ATTACHMENT 2

DETAILED ASSESSMENT REPORT

The Planning Proposal seeks to amend *Willoughby Local Environmental 2012* planning controls for 3-5 Help Street in the following manner:

Figure 5 – Sun Access Protection

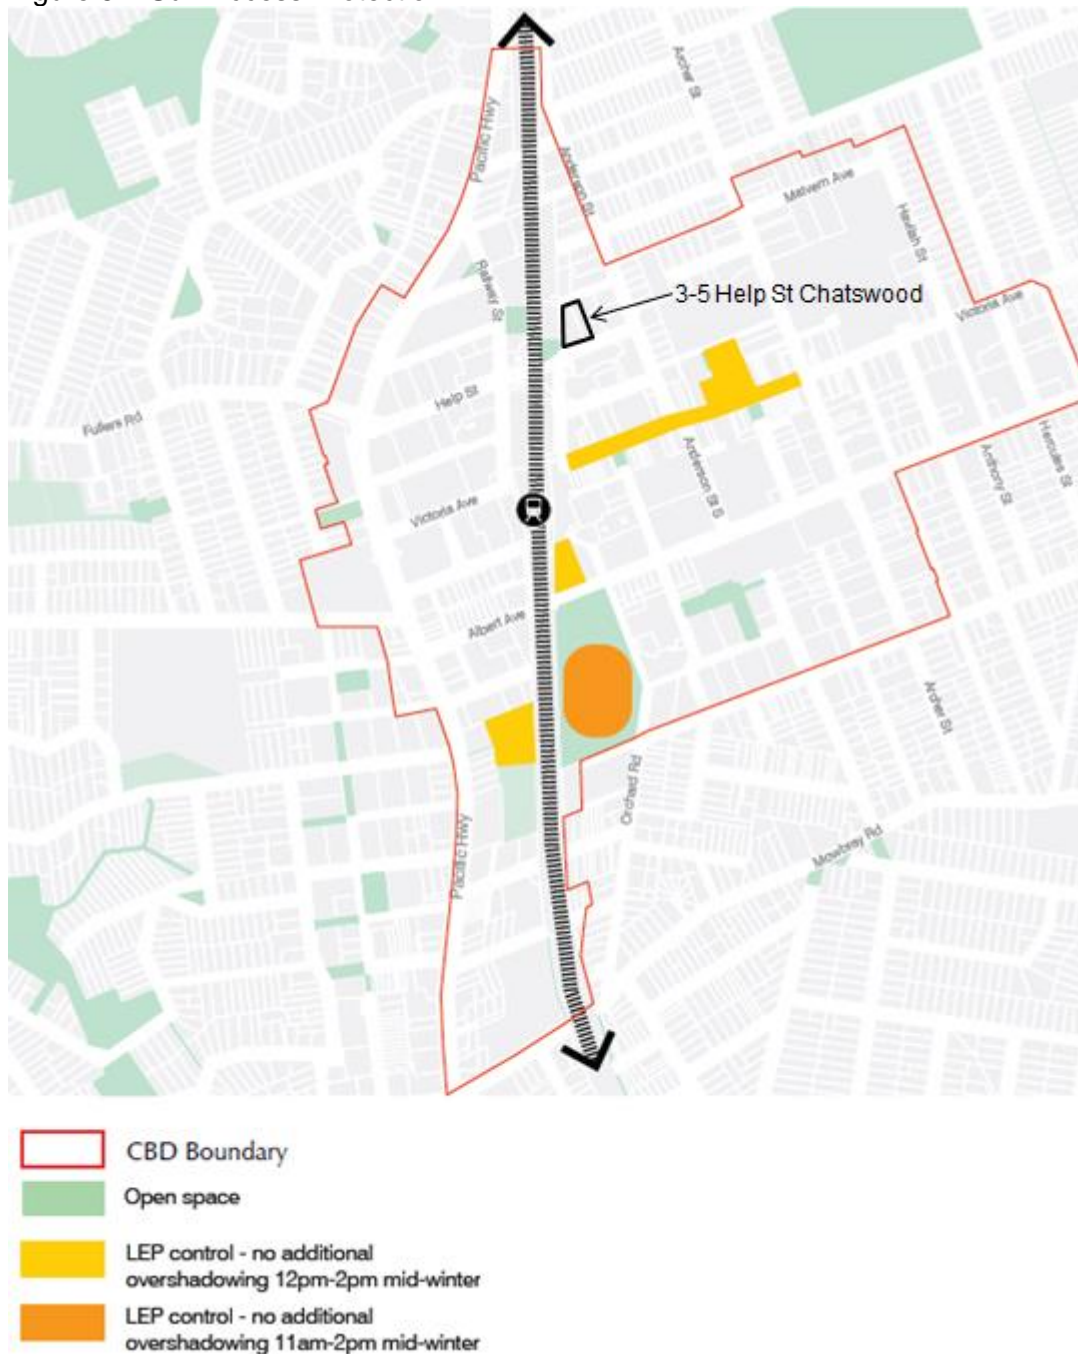
The site is located north of any public open space area identified within the Chatswood CBD as requiring sun access protection and is in a location that has the potential to impact sun access to Victoria Avenue (between the interchange and Archer Street) between 12-2pm in the winter solstice. Refer as shown below in Figure 5 - Sun Access Protection.

Concern exists with the impact of the heights that the Concept plans have on sun access for Victoria Avenue.

The following is recommended for the draft *Development Control Plan* in order to ensure protection of sun access to key public spaces.

Delete existing 14 and replace with:

“Maximum height of buildings in the CBD will be based on Figure 3.1.6 of the *Chatswood CBD Planning and Urban Design Strategy* up to the airspace limits (Pans-Ops plane) except as reduced further to meet: a) Sun access protection”

Figure 6 – Height of Buildings

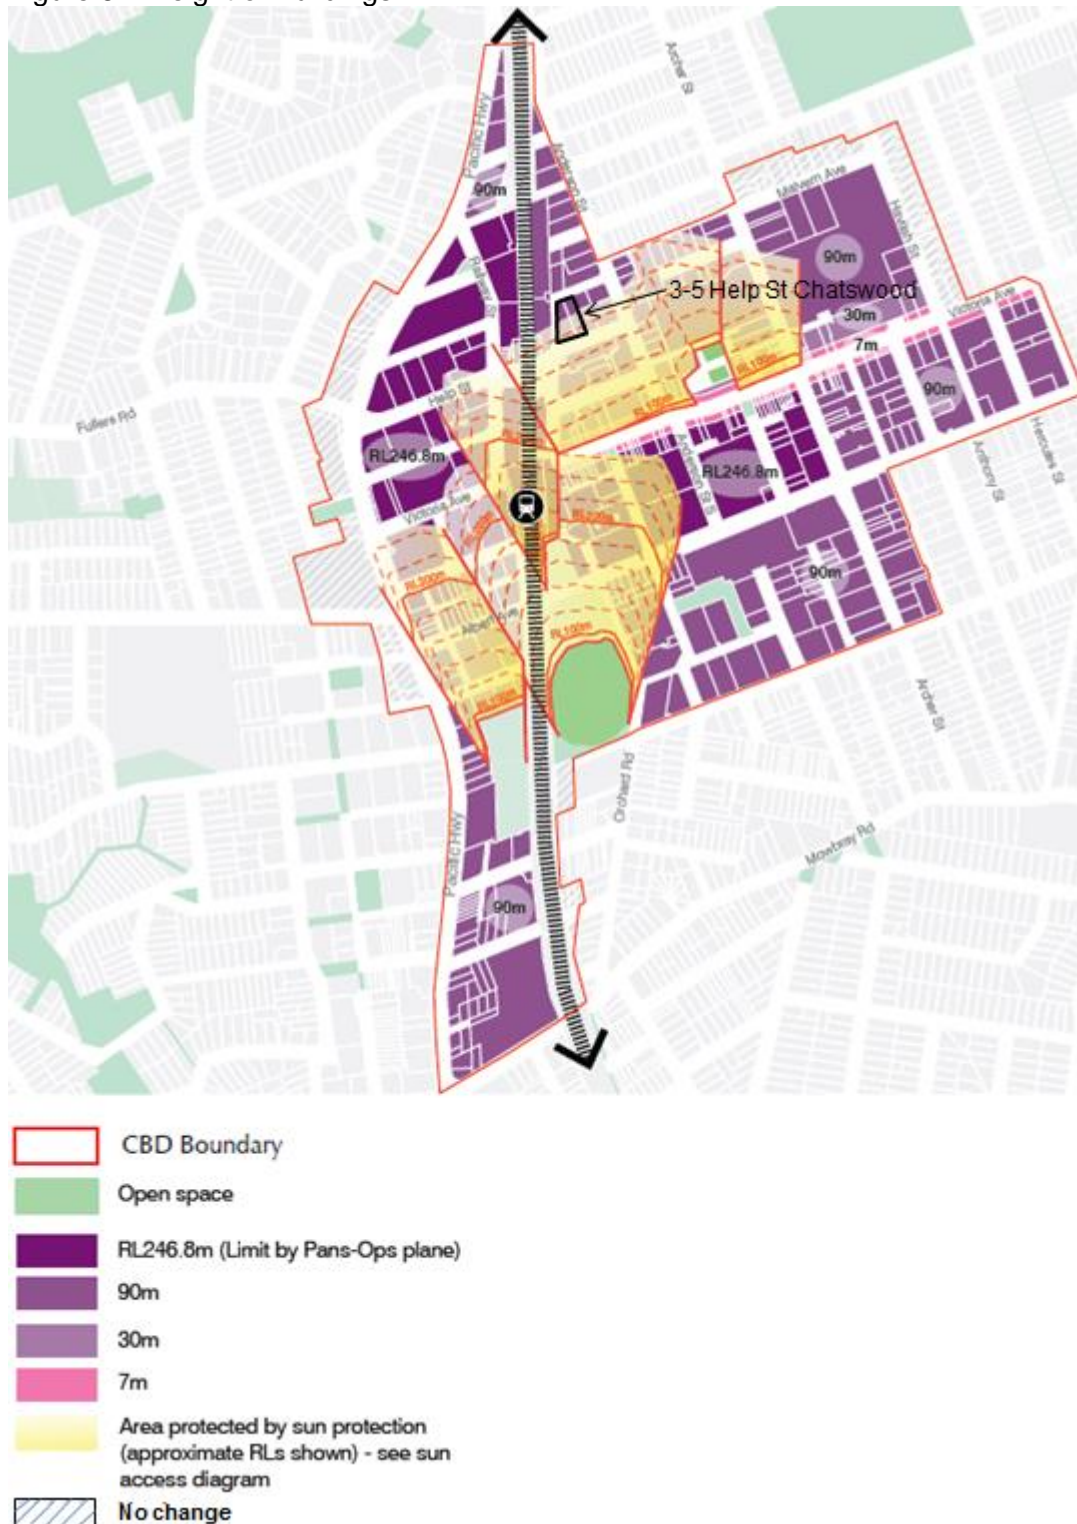
As discussed in Key Element 19 above, there is concern regarding whether the Planning Proposal is consistent with the height maximum due to a 90m maximum for the north of the site and a sun protection RL maximum for the south of the site.

It is unclear from the Concept plans submitted whether the height is in accordance with the height maximum for the sites. The Council Resolution recommends the submission of amended plans prior to referral to Gateway, showing compliance with the *Chatswood CBD and Urban Design Strategy* regarding height.

The recommendation to address this requires an updated Concept plan that confirms compliance with the 'Sun Access to Key Public Places - Key Element 19', and 'Building Heights - Key Element 20 and Key Element 21' of the *Chatswood CBD Planning and Urban Design Strategy*.

Amended Concept plans are required prior to gateway to ensure the Planning Proposal is consistent with Key Element 20 of the *Chatswood CBD Planning and Urban Design Strategy*.

Figure 7- Links and New Open Space.

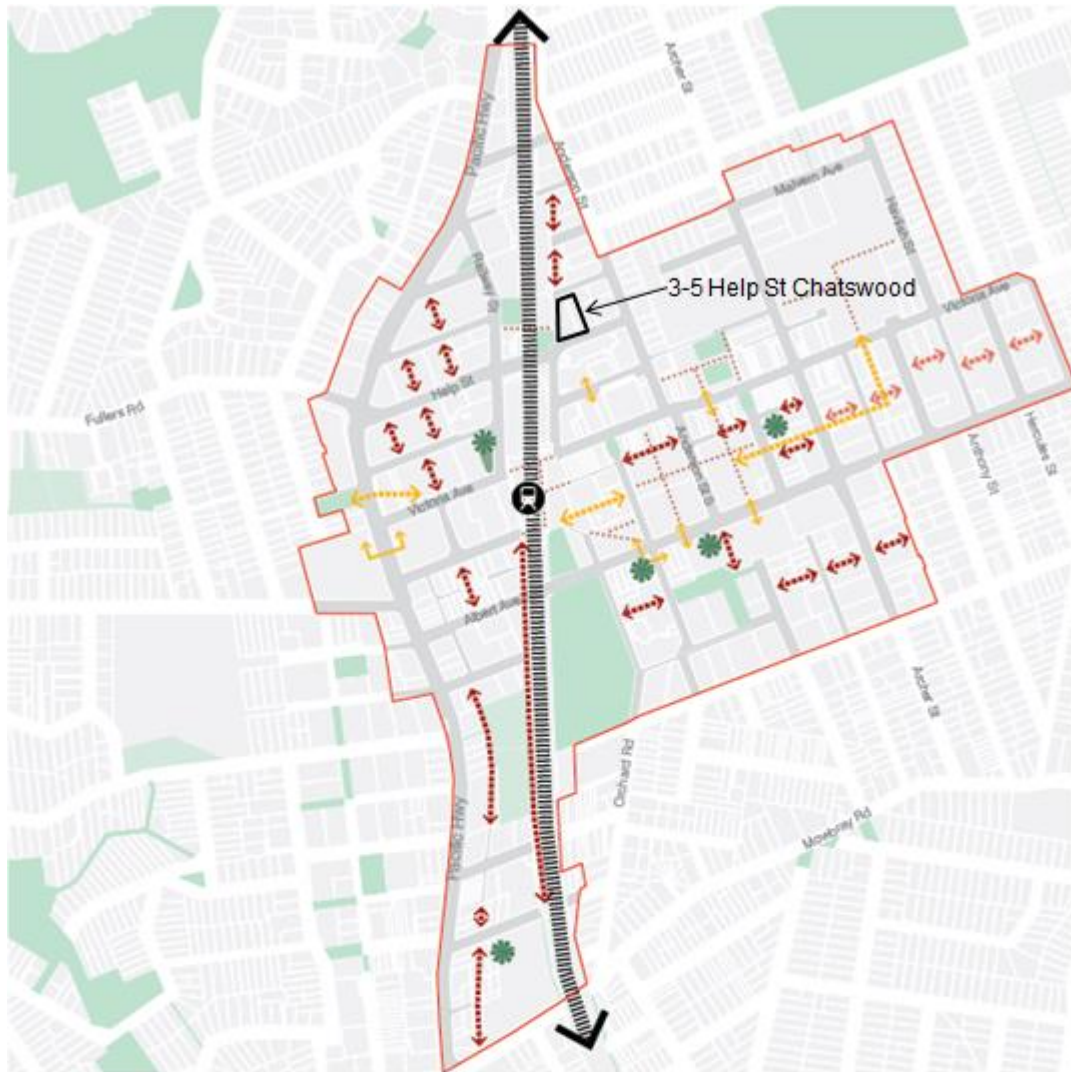
It is noted Cambridge Lane serves an important shared zone, connecting to other shared zones to the north linking with the centre of the Chatswood CBD. This importance is considered in the *Development Control Plan* provided.

As part of these considerations, any widening along Cambridge Lane is encouraged. This can be demonstrated as part of the Concept Landscape Plan to be provided as noted in discussion of Key Element 23 below.
